Service Bulletin 471

Model Affected: MedSystem III® Multi-Channel Infusion Pump - 286X
Date: December 2000
Subject: Drive Module Assembly Motor with Date Code 448

Purpose

Figure 1 - Date Code Location on Drive Module Assembly Motor

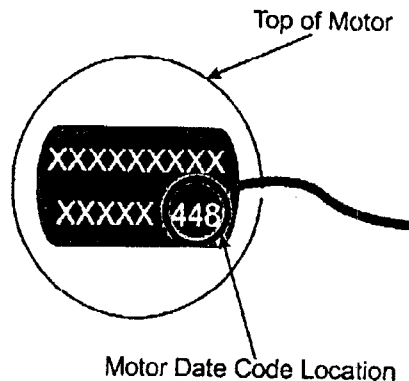
9. Examine the date code on the drive module assembly motor. The date code is found on the black colored cover on top of the drive module. (*See figure 1*)
 - a. If the date code on the drive module assembly motor is 448, proceed to step 10.
 - b. If the date code on the drive module assembly motor is **not** 448, complete the troubleshooting process per the guidelines provided in the service manual and applicable service bulletins.

10. Replace the drive module assembly using the installation instructions provided as part of the drive module assembly replacement kit.

- Verify that the replacement assembly does **not** have a motor with date code 448.
- Ensure proper lubrication is applied to the cams of the replacement assembly. (*Reference Drive Module Assembly Repair section, 7.3.5; Reassembly step, c.2 - in Repair chapter of service manual.*)
